ATTACHMENT
TO
AECM-84/0338 (6/19/84)

PROPOSED CHANGES TO THE
GRAND GULF NUCLEAR STATION
TECHNICAL SPECIFICATIONS

NRC TECHNICAL REVIEW BRANCH: RADIOLOGICAL ASSESSMENT

FIGURE 5.1.1-1

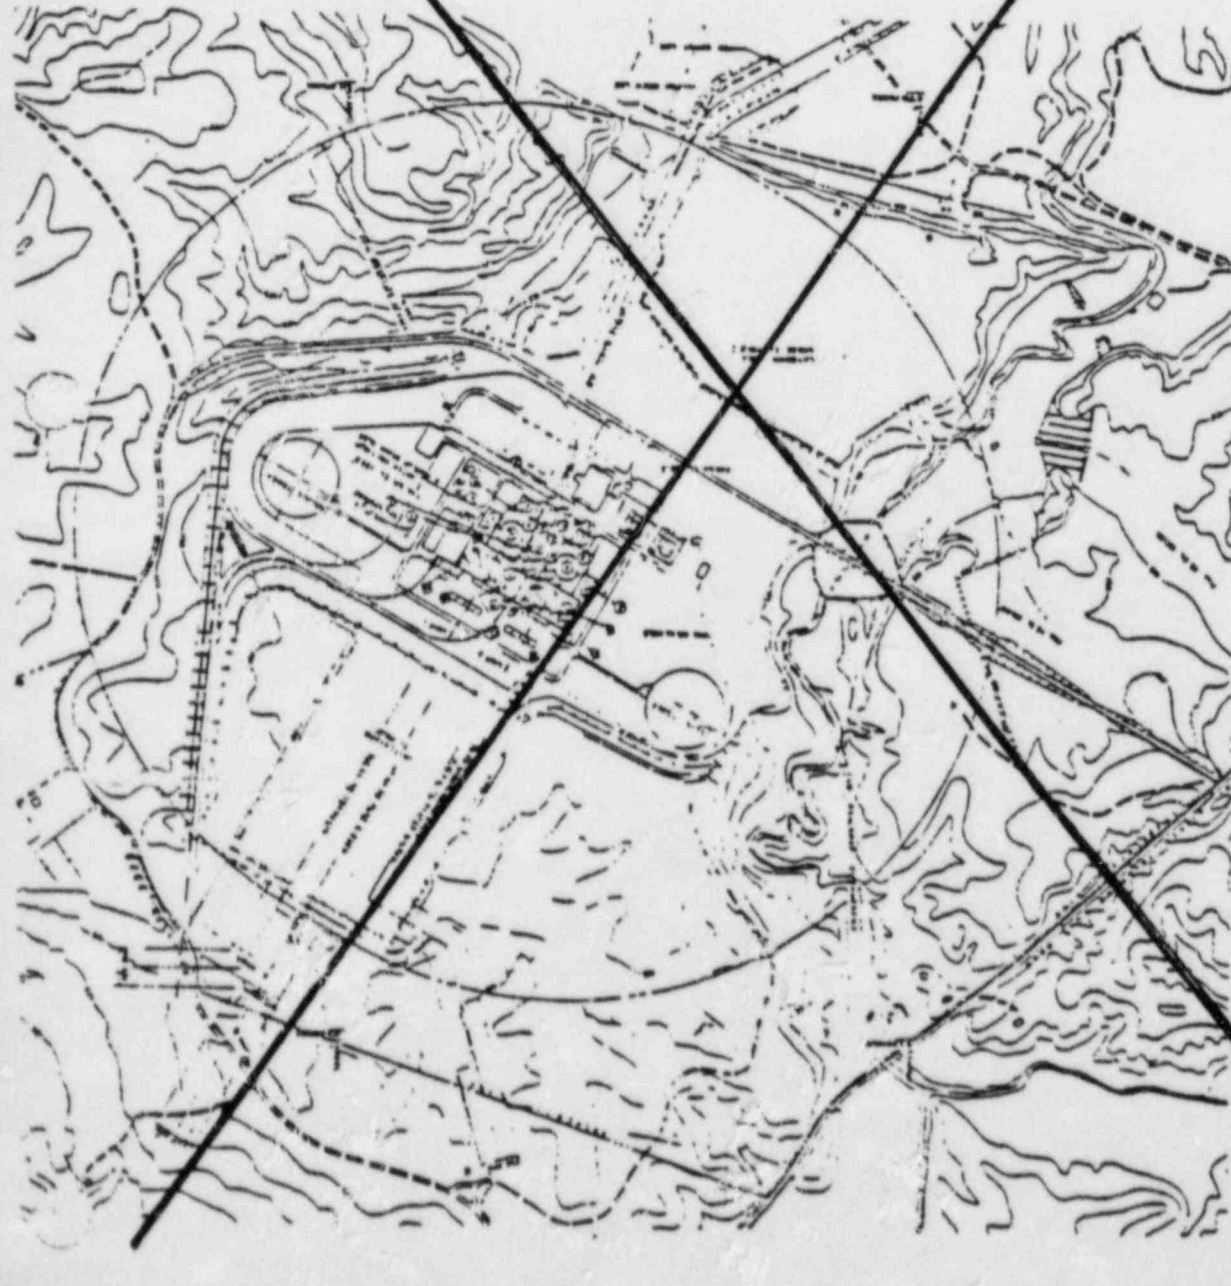
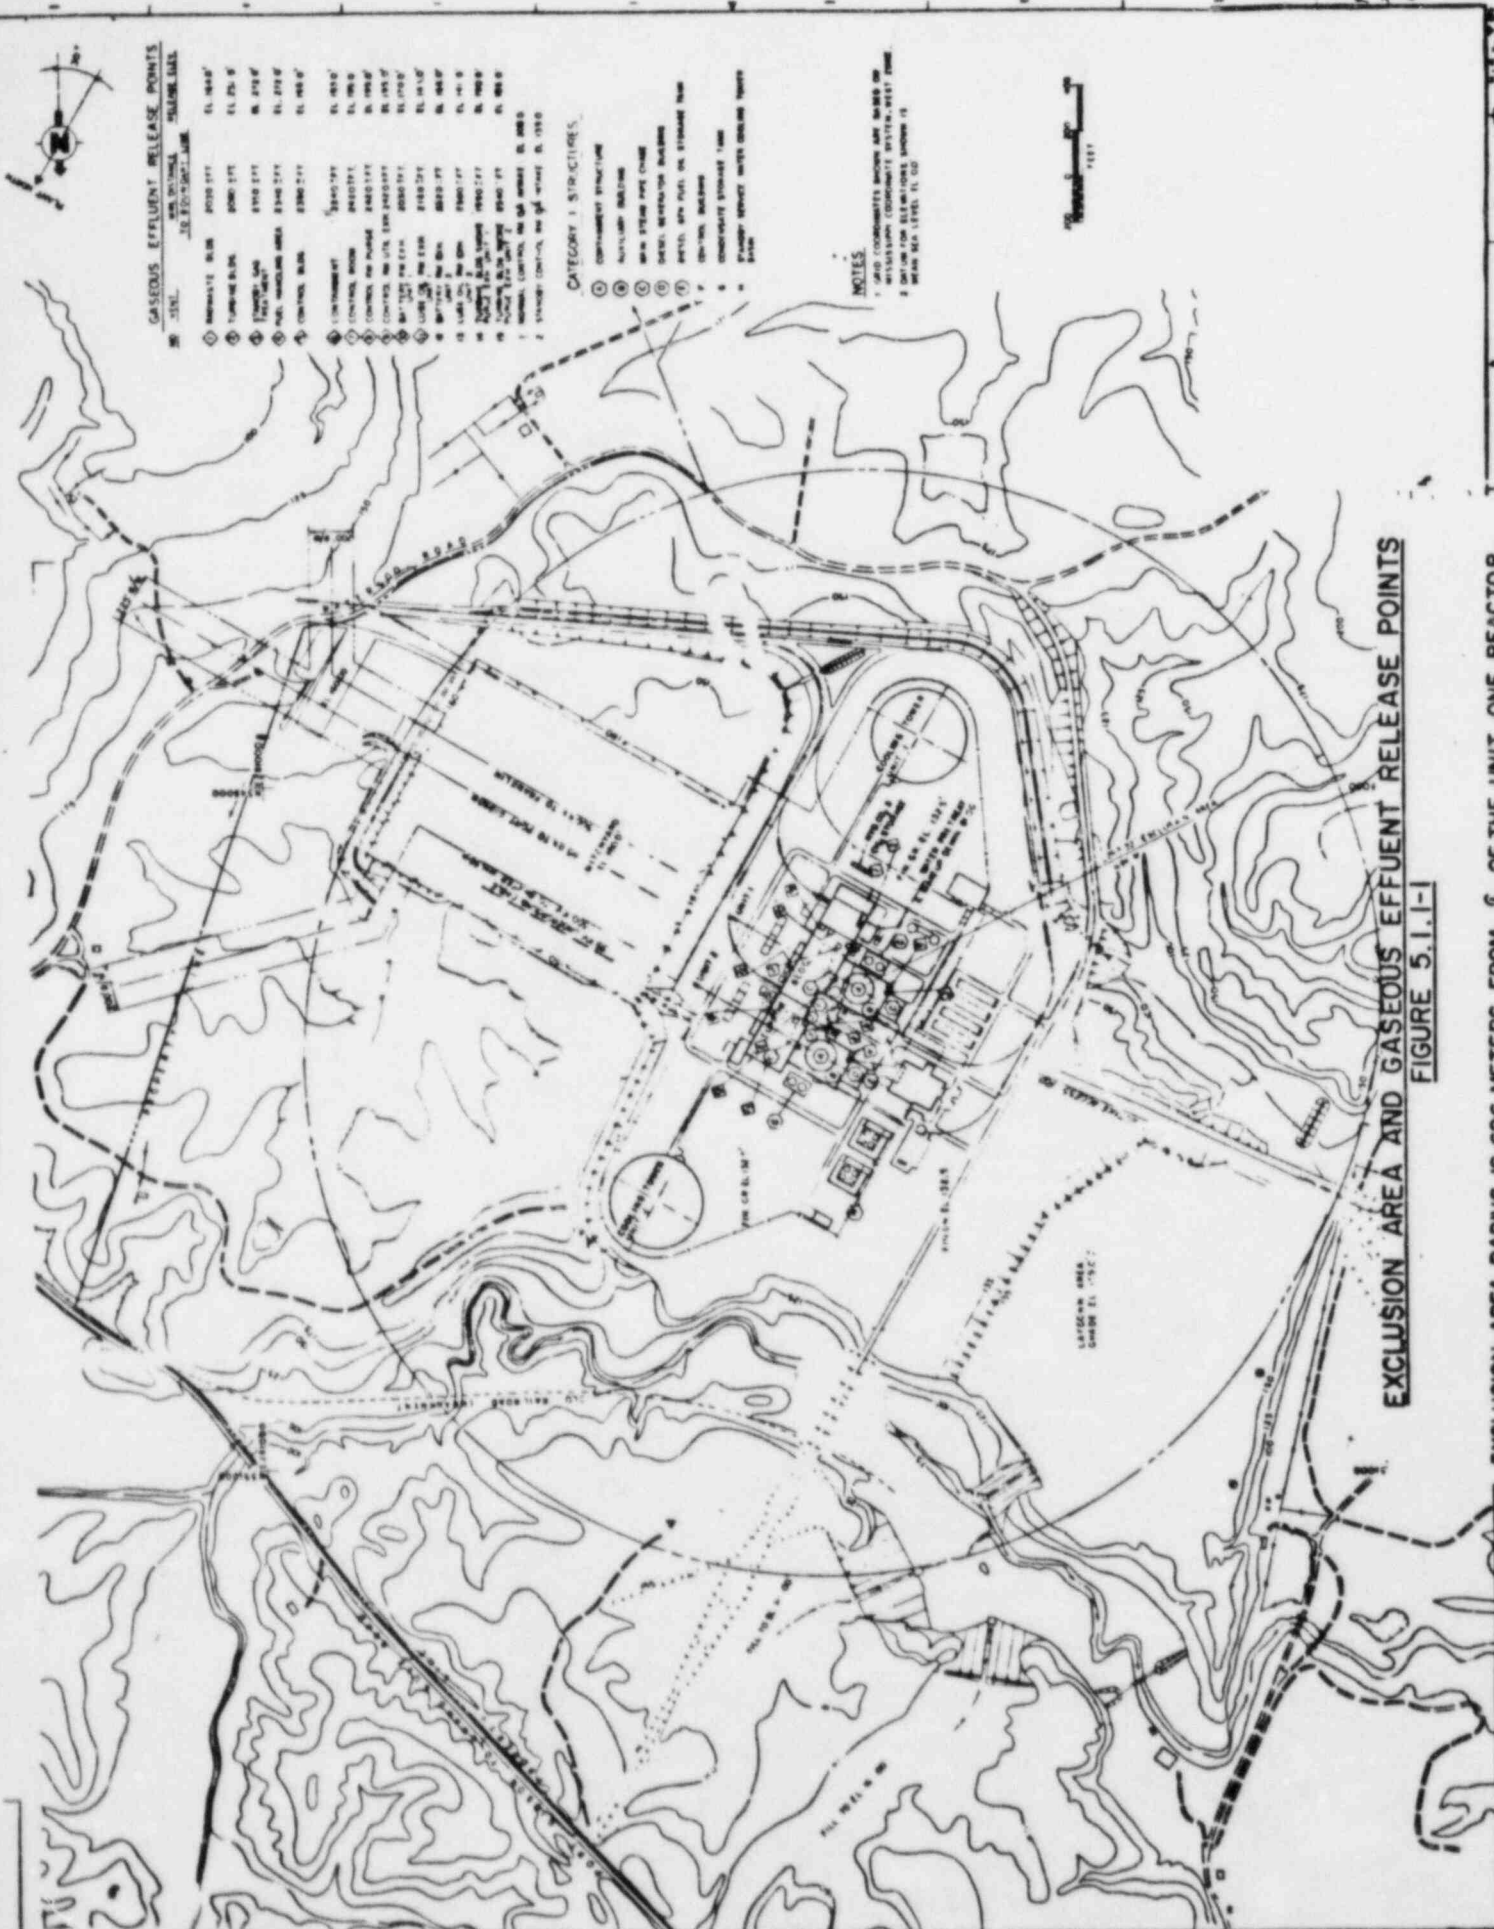
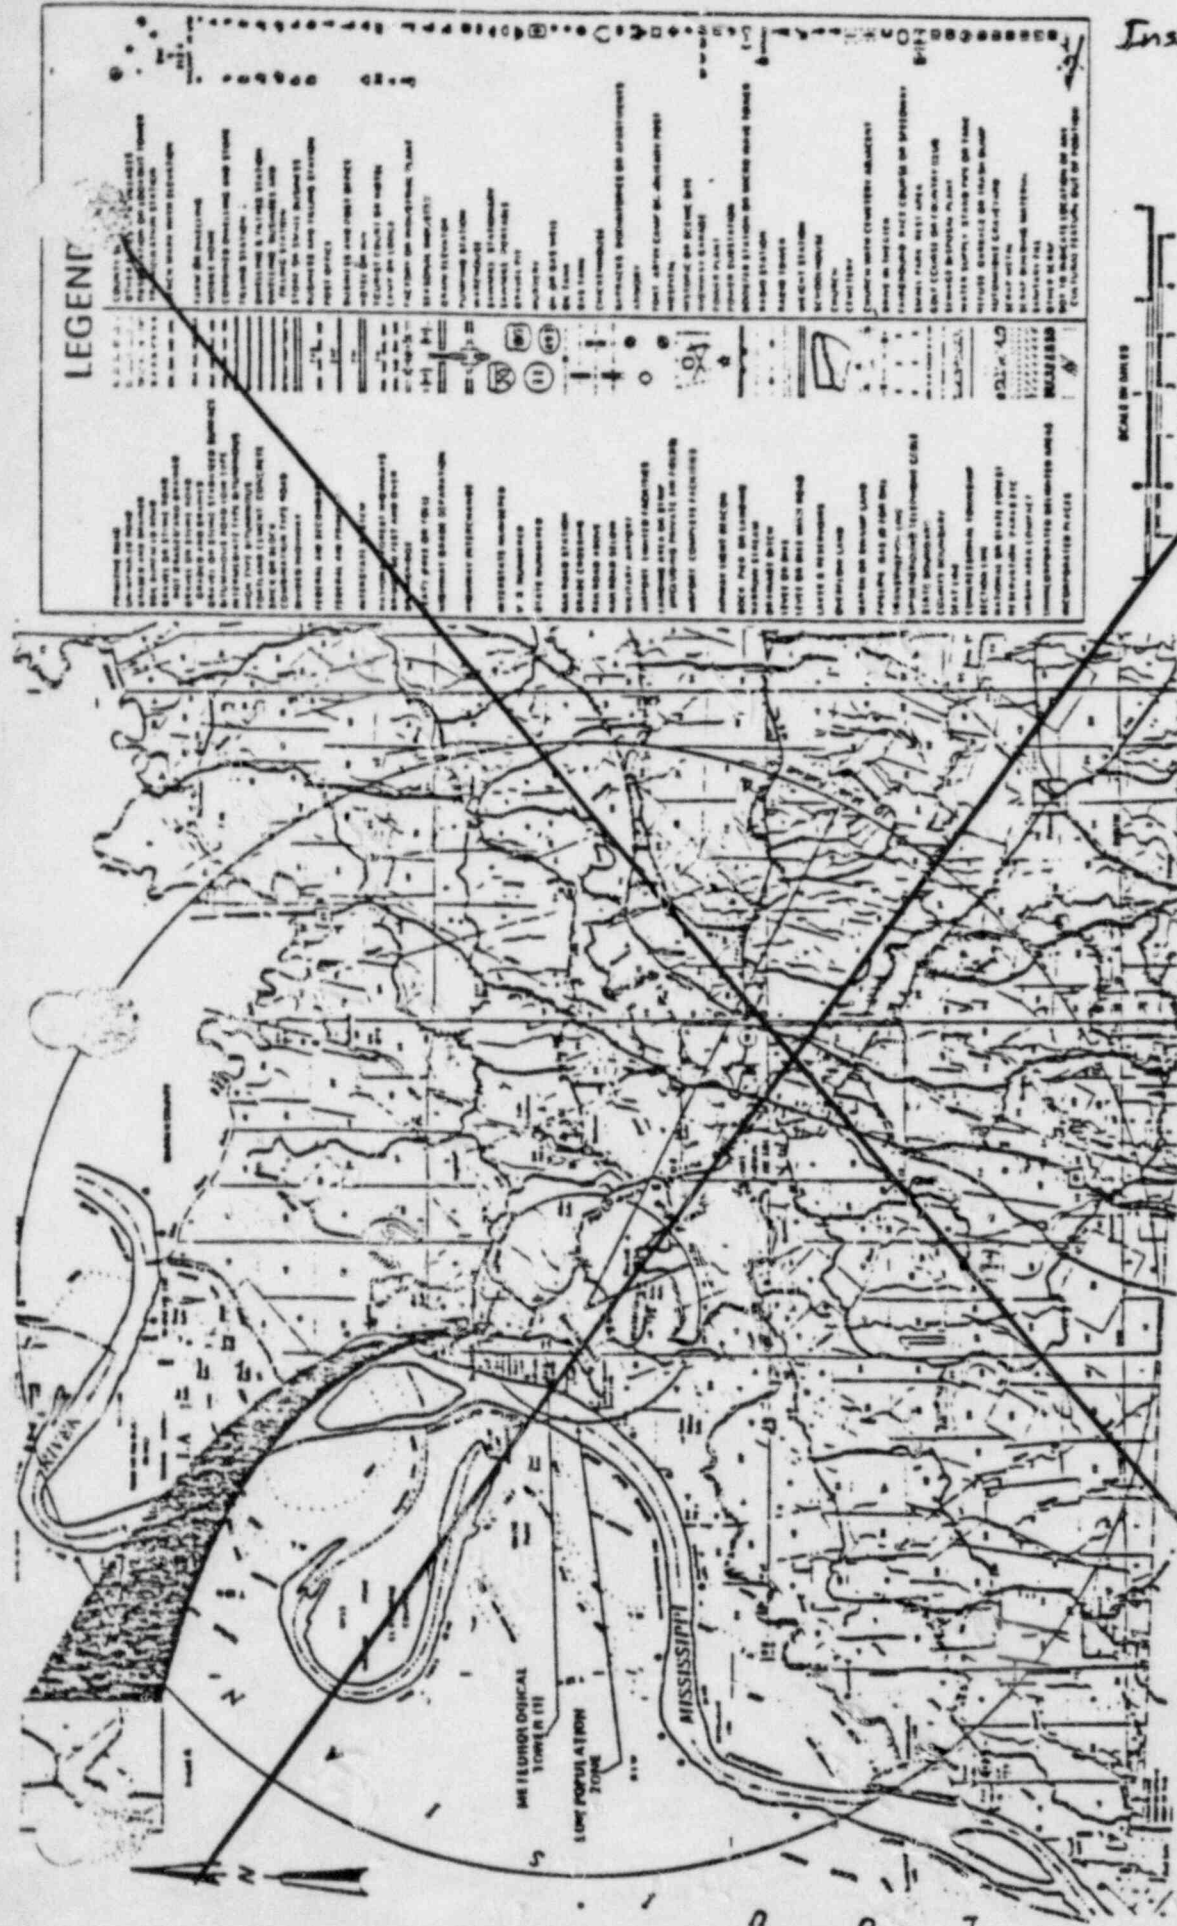
Legible copies of the subject figures are submitted to replace the figures currently found in the technical specifications. All of the subject figures have been redrawn to improve legibility including deletion of typographical lines. These changes are administrative in nature and are submitted in response to NRC concerns over the readability of the subject figures. In addition, Figure 5.1.3-1 has been enhanced by adding the effluent release points. (Pages 5-2, 5-3, 5-4)

FIGURE 5.1.3-1

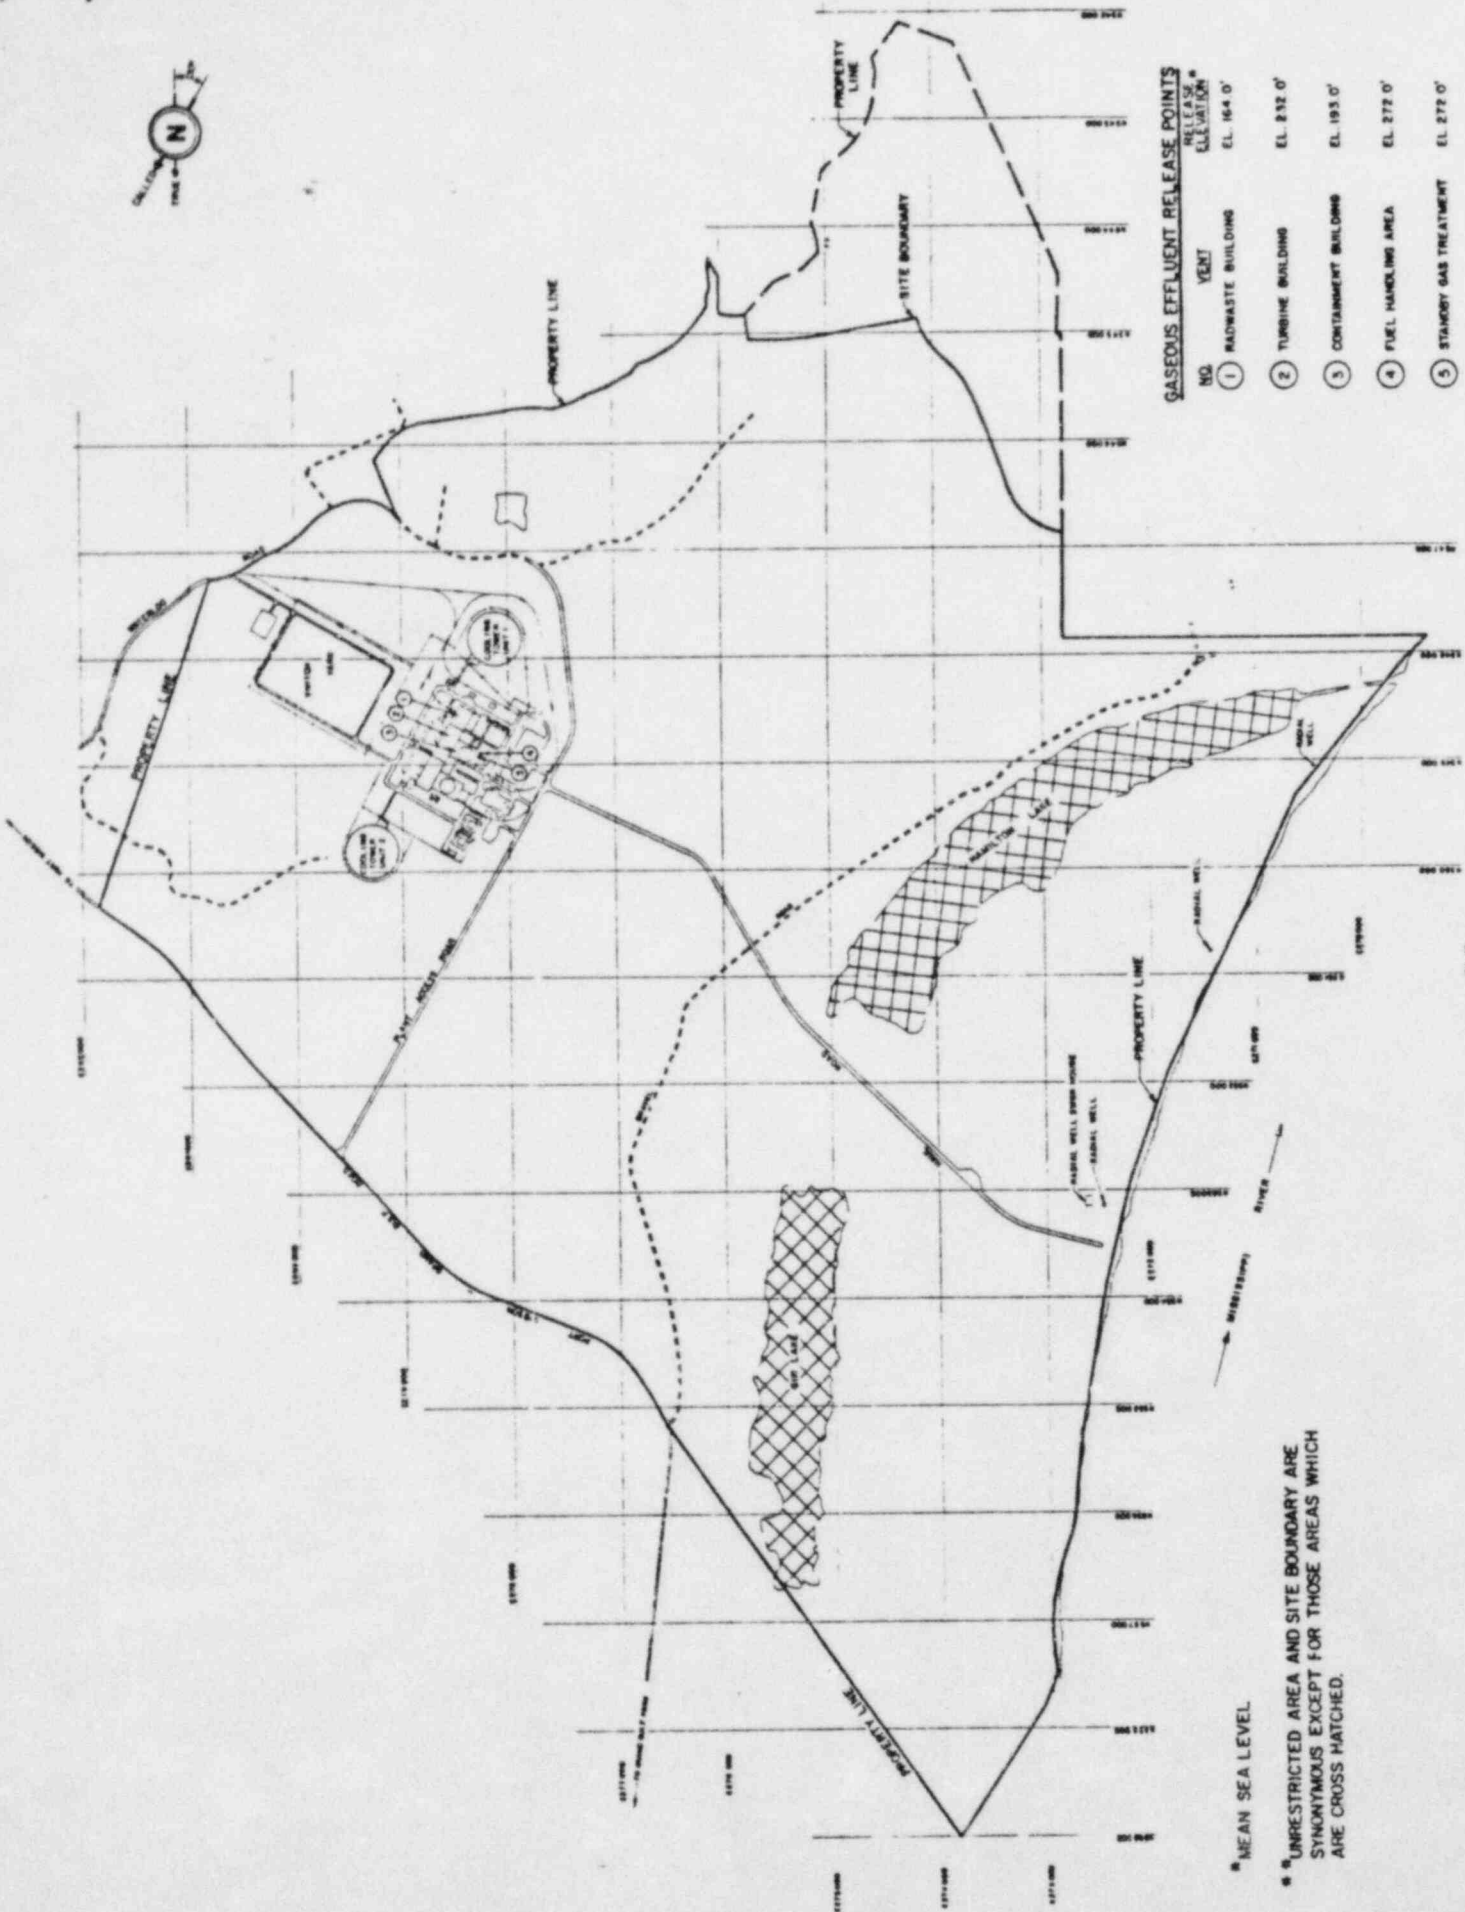
A revision to Technical Specification 5.1.3 is requested to change the "UNRESTRICTED AREA BOUNDARY" terminology in this design feature summary to "UNRESTRICTED AREA and SITE BOUNDARY." This proposed change will achieve consistency throughout the technical specifications with the new definition for UNRESTRICTED AREA and the new definition for SITE BOUNDARY. This proposed change involves no safety significance as it represents a purely administrative change of an editorial nature for the purpose of providing consistency in the technical specifications. (Pages 1-8, 3/4 11-8, 3/4 11-13, 3/4 11-15, 3/4 12-3, 5-1, 6-18, B 3/4 11-2, B 3/4 11-3, B 3/4 11-4, B 3/4 11-5, B 3/4 12-1)

5.1.3 ~~The unrestricted area boundary~~ ^{The UNRESTRICTED AREA and SITE BOUNDARY} for gaseous effluents and for liquid effluents shall be as shown in Figure 5.1.3-1. The gaseous effluent release points are shown in Figure 5.1.1-1.
